**DESCRIPTIVE REPORT**

Registry Number: H12830

General Locality: Kotzebue Sound, AK

Project: OPR-S327-FA-15

*Junctioning surveys H12830 and H12829.*

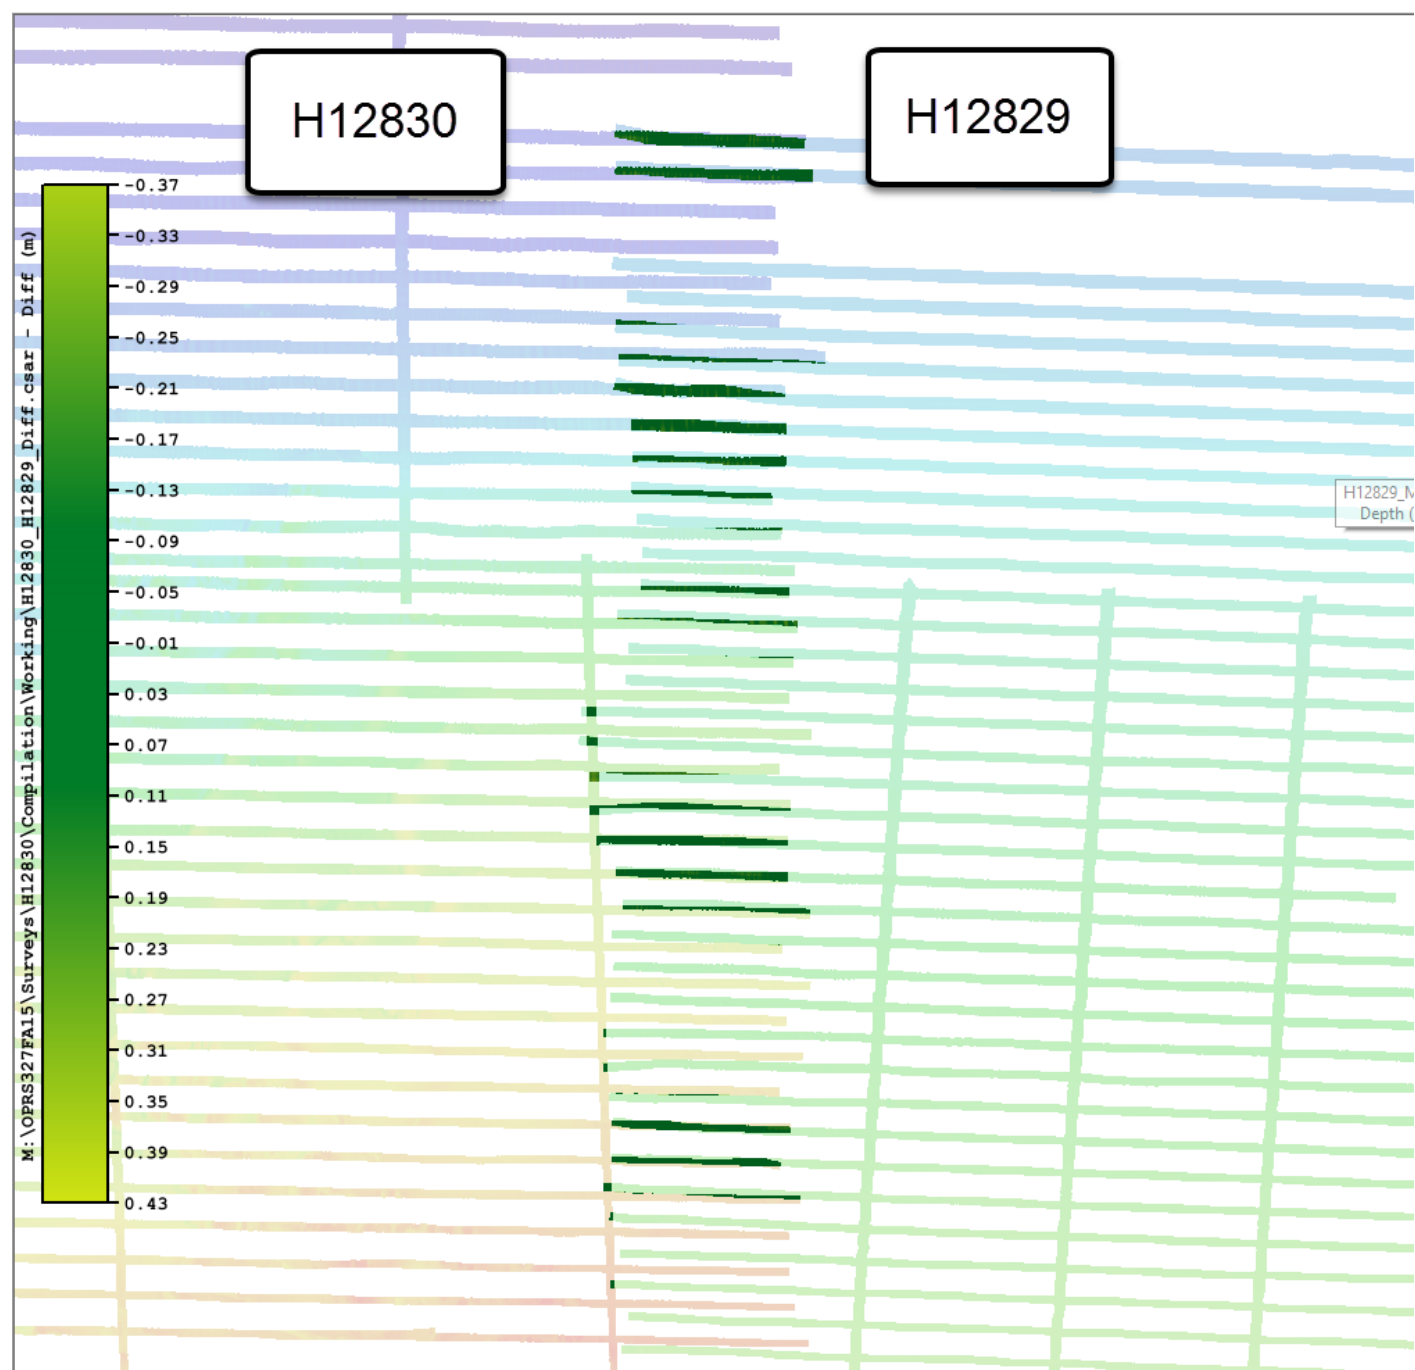
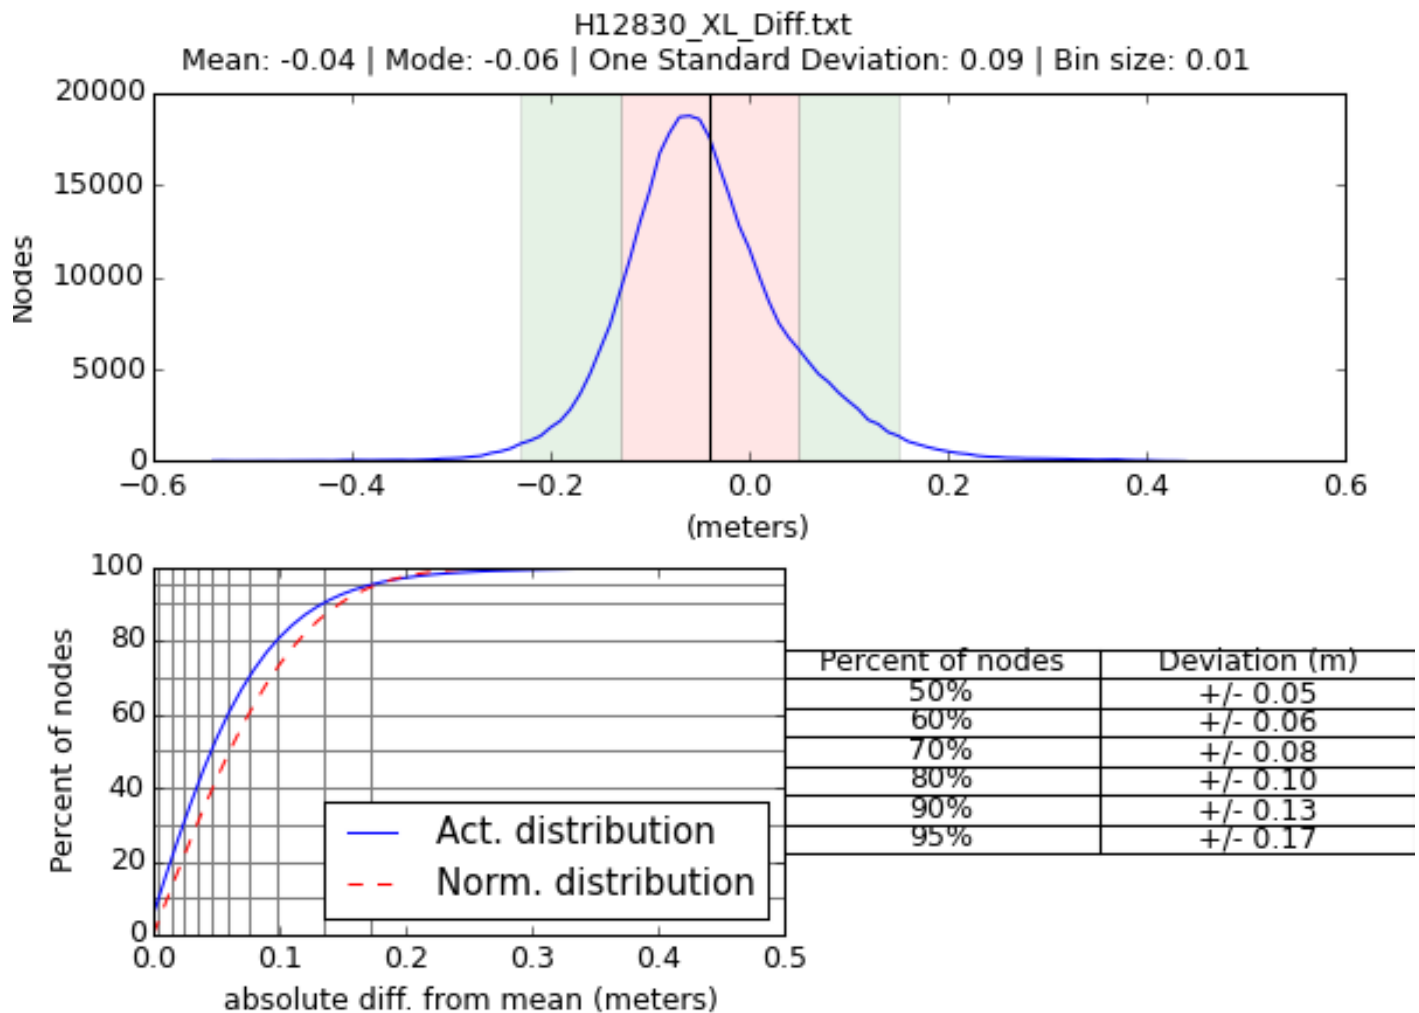
*One contemporary survey junctions with this survey and a junction analysis was conducted at the processing branch to assess surface agreement. A 2-meter combined surface was created for H12829 and then differenced with the 2-meter combined surface of H12830. Both surveys employed set-line spacing methods resulting in intermittent overlap of tracklines (see images below). The difference surface was analyzed (output below) using the BDB Surface ASCII Export Stats tool in Pydro and indicates that 95% of surface nodes have a maximum deviation of +/-0.17 meters.*

*Difference surface statistics calculated in Pydro indicate that 95% of surface nodes have a maximum deviation of +/- 0.17 meters.*

Figure 7: H12830 Southeast corner refraction seen in gray and through the side scan view.

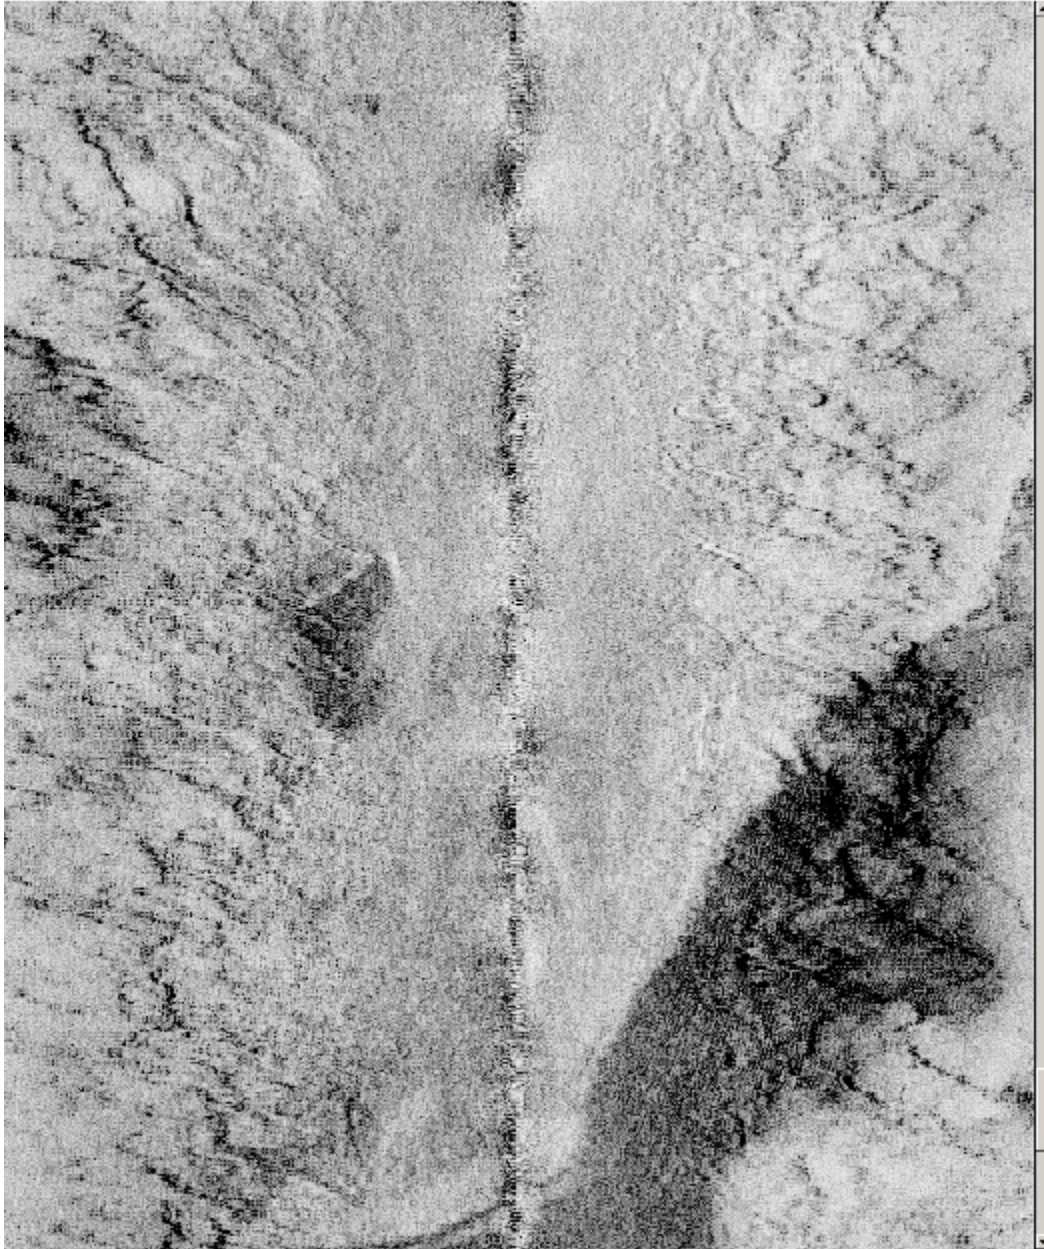
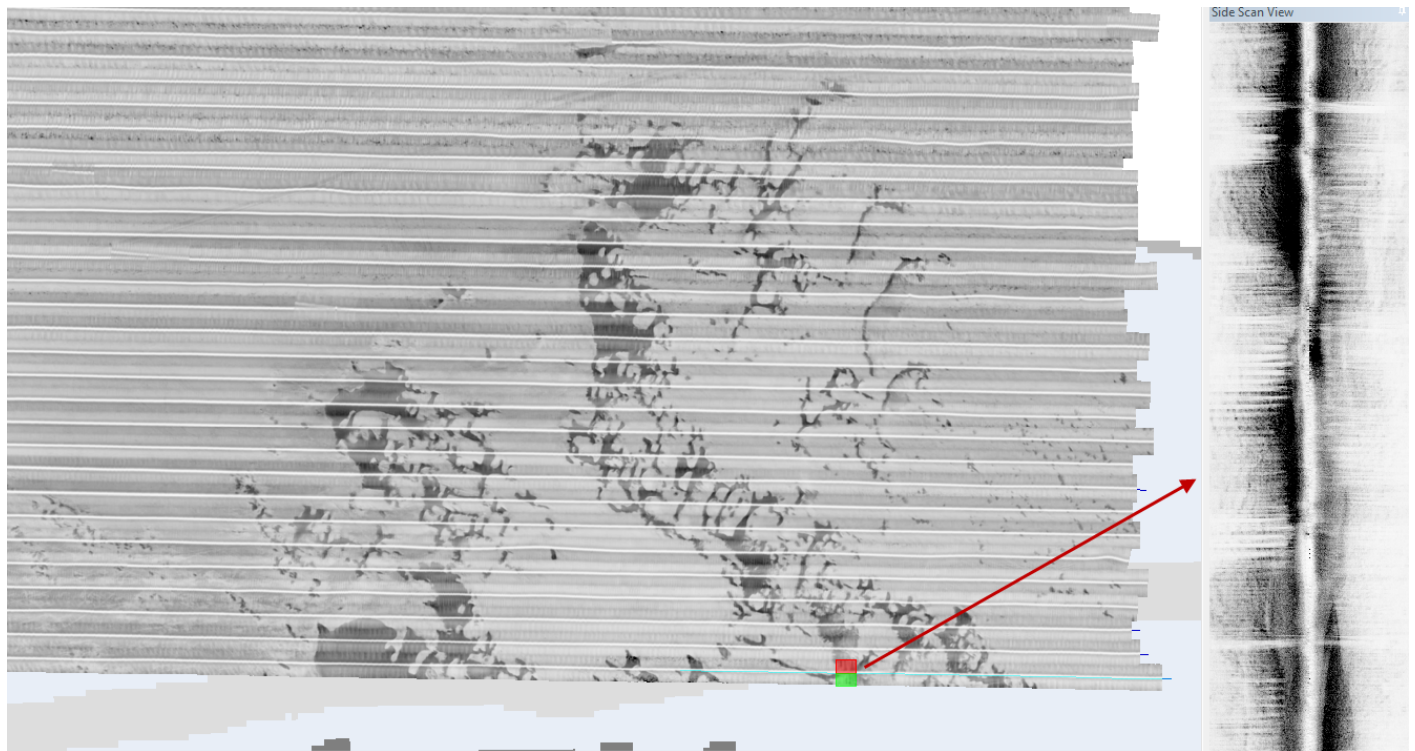
Refraction was present in the southeast corner of sheet H12830. The refraction is due to the presence of a pycnocline in the water column, a very common effect in this area. See Figures 6-7. The altitude of the towfish was changed to mitigate this issue when possible, and flying under the pycnocline was found to return the cleanest data. However, due to the variable altitude of the density layer and not being able to safely

*This area was not re-acquired and the refraction still exists in the SSS data. The adjacent SSS data and MBES data was reviewed at the Processing Branch for indications of significant shoals or pinnacles. While this area of the survey has a slightly more dynamic seafloor, it is still relatively flat with no indications of significant shoals. The imagery is adequate to be considered 100% SSS coverage as required by the Project Instructions.*

Figure 10: H12830 Line 099\_20150808\_125654\_S220\_M showing the applied SBET file.

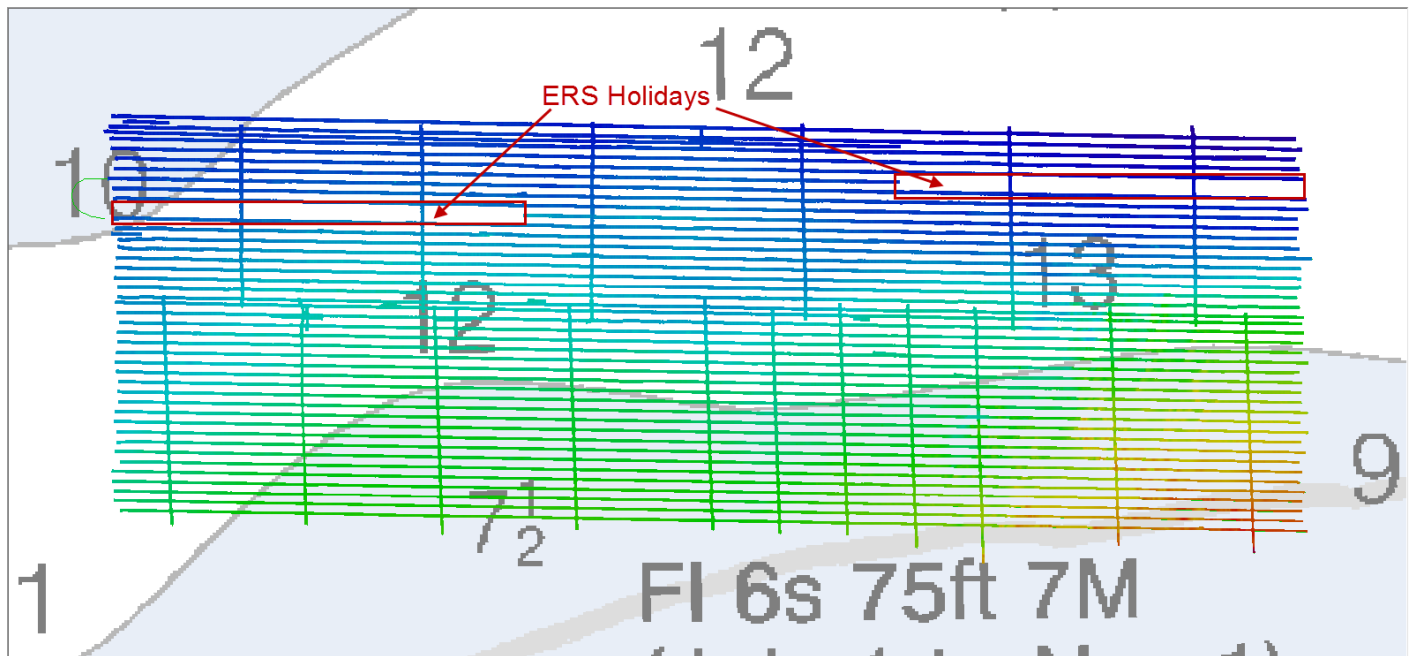
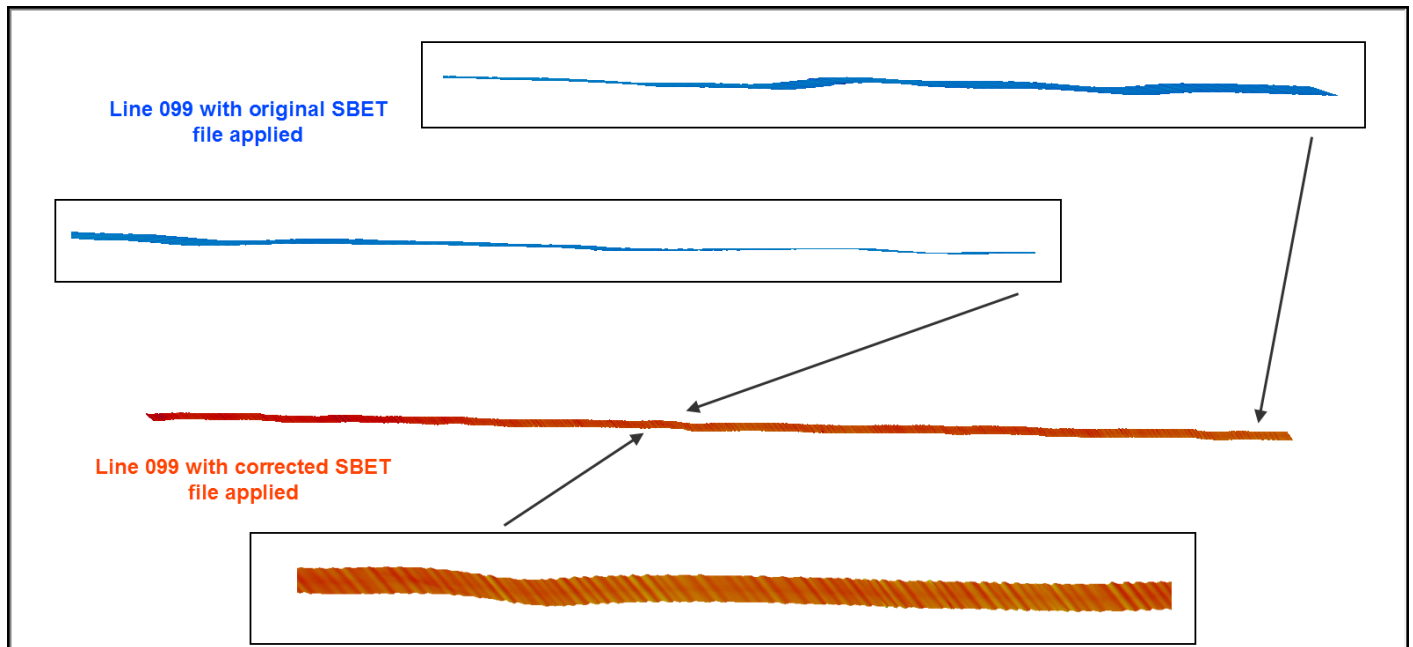
Line 099\_20150808\_125654\_S220\_M was not able to be processed to the ellipse. While the tidal data looked fine, applying the SBET file created an unexplained 90 degree offset of the ship's heading as seen in Figure 10. Extensive troubleshooting was conducted including reprocessing the line and SBET, however, the offset remained. No adjacent lines experienced the same impacts, and the hydrographer was unable to determine the root cause for the offset. As the offset could not be resolved and no obstructions requiring further investigation were found in the data, the hydrographer decided to remove line 099 from the project, creating a holiday in the northeast section of the survey. The field unit had left the survey area by the time this offset was discovered and was unable to reacquire the data.

Line 0102\_20150808\_143416\_S220\_M was removed from all surfaces due to low quality trajectories from applying SBET files. This created a second ERS holiday on sheet H12830. An overview of ERS holidays on sheet H12830 can be seen in Figure 9.

*Line 099\_20150808\_125654\_S220\_M was removed from the surface, not the project. The data is adequate for charting despite the presence of the holiday.*

*Figure 15: Discrepancy in 10 fathom contour within Chart 16005.*

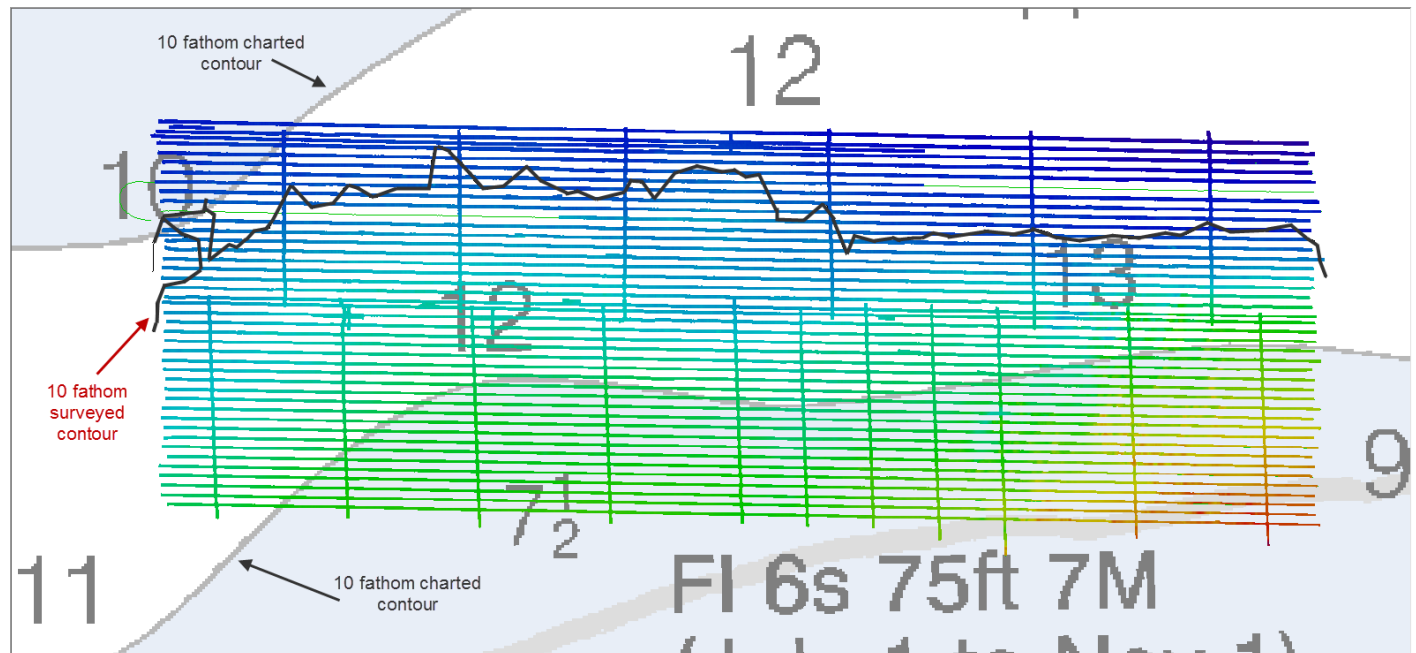
Contours generated in CARIS HIPS and SIPS consist of a 10 fathom contour. On chart 16005, the 10 fathom contour exists within the sheet limits of H12830. The new surveyed 10 fathom contour runs parallel with the charted contour approximately 2,000 meters to the north of the charted contour (Figure 15).

*The charted 12 and 13 fathom soundings do not represent the surveyed depth as the surveyed depths are shoaler by approximately 3 fathoms. The charted 10 and 7.5 fathom soundings do not represent*

*the surveyed depth as the surveyed depths are deeper by approximately 0.3 fathoms and 1 fathom, respectively.*

Figure 16: Discrepancy in sounding depths vs. surveyed depths on ENC US1AK90M.

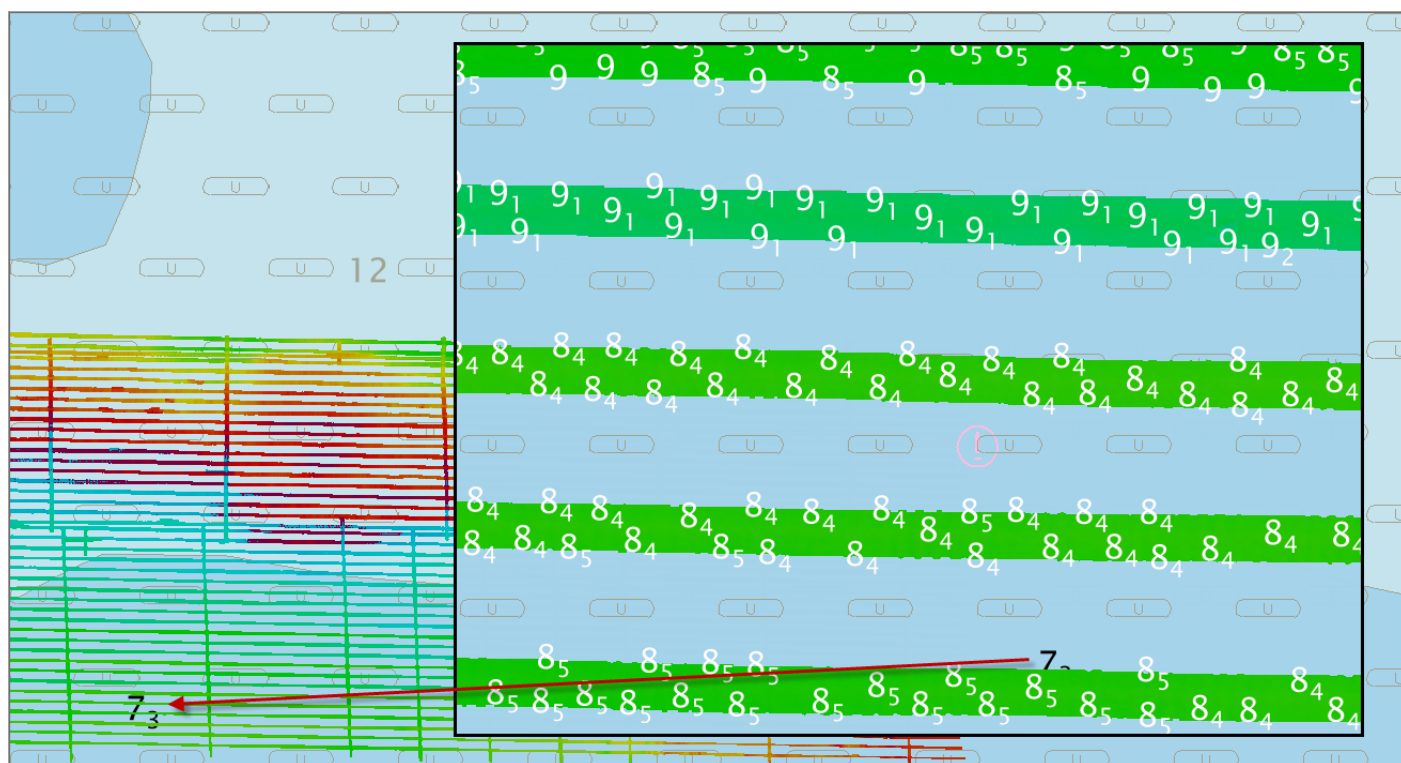
In the northeast portion of H12830 surveyed depths were consistently deeper by 1.5 fathoms than sounding depths on US2AK92M (Figure 16).

*The description of the deeper surveyed depths is located in the southwest portion of the survey, not the northeast as stated above.*
